University of South Carolina

Project Name: UTS MOD Closet Electrical Upgrades - Various Buildings

Addendum Number Two

From: Belka Engineering Associates, Inc.

E2

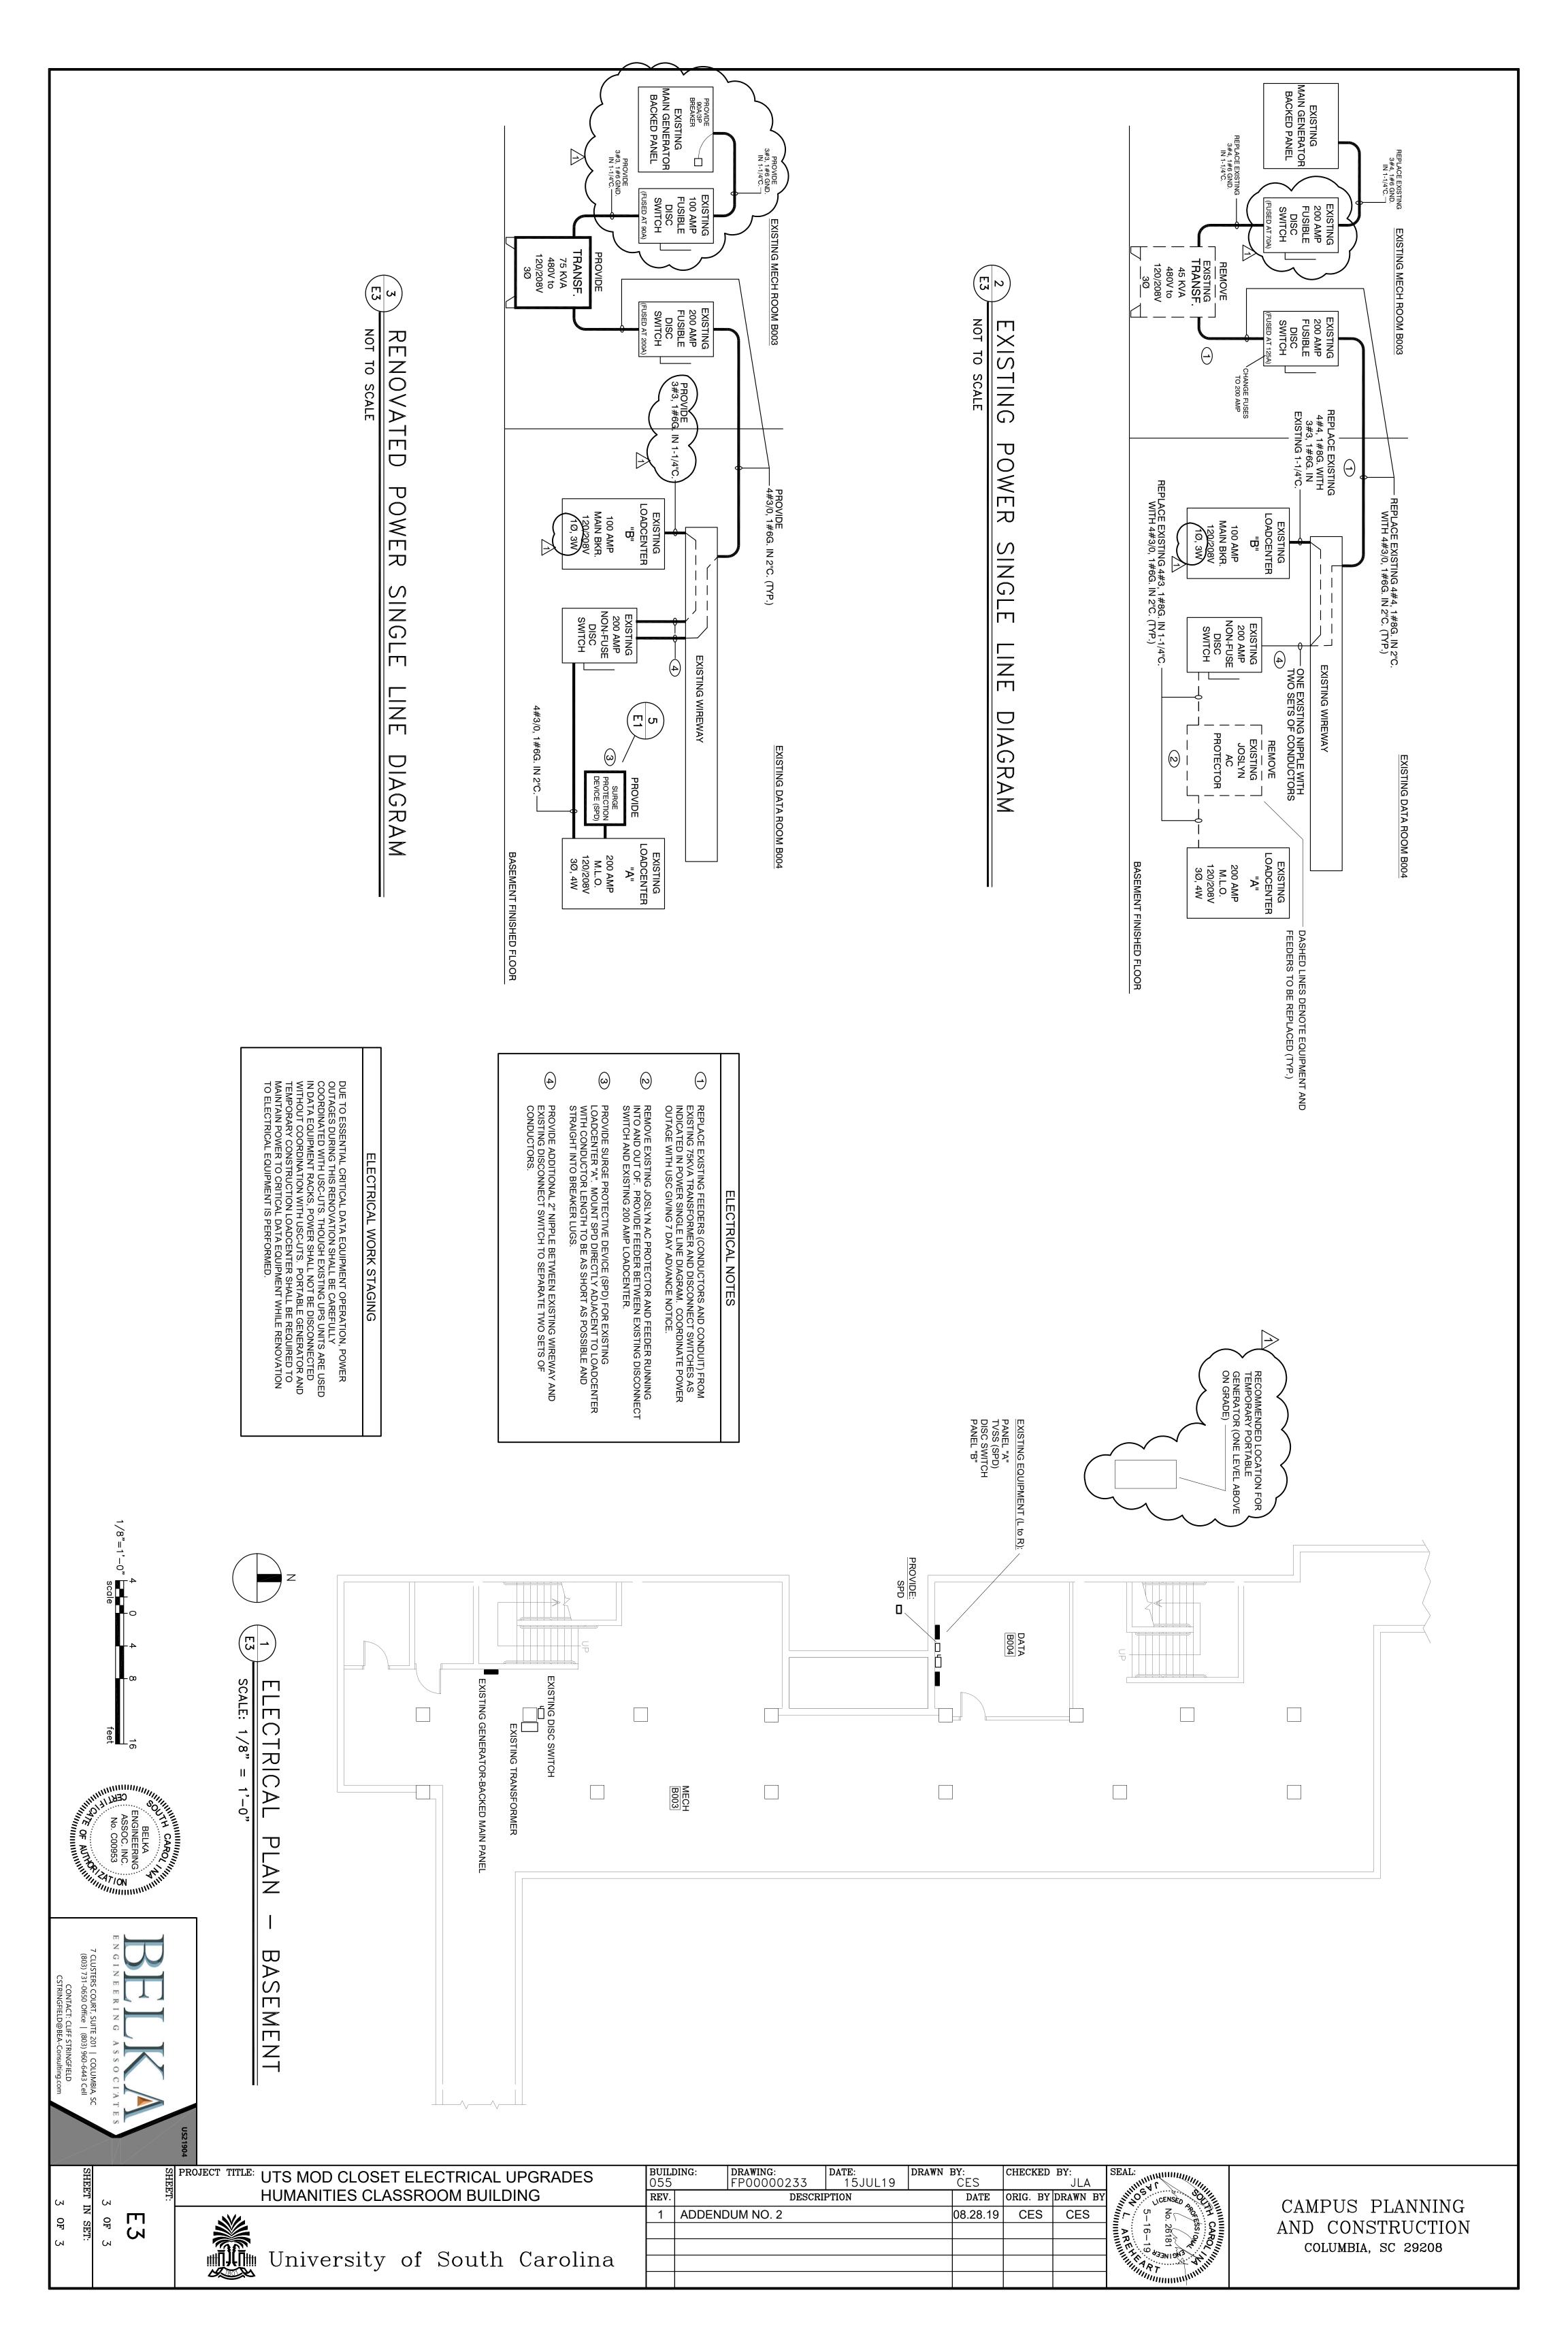
- 9. Q: Will a 60kW unit be sufficient since only a 200-amp breaker is required (60kW is rated at 205 amps, 65kW is rated at 225 amps)?
 - A: Agree. Generator shall be changed from 65kW to 60kW and automatic transfer switch from 225 amps to 200 amps. See revised drawing E2.

- 5. Change layout of new generator as shown on attached revised drawing E2 (rotate and reposition for future equipment considerations coordinate with USC project manager).
- 6. Provide new 48-hour, skid mounted fuel tank with generator.
- 7. Change generator rating from 65kW to 60kW and automatic transfer switch from 225 amps to 200 amps. Change associated conductors/conduits as shown on attached revised drawing E2.
- 8. Existing generator is 30kW, not 45kW as previously shown.
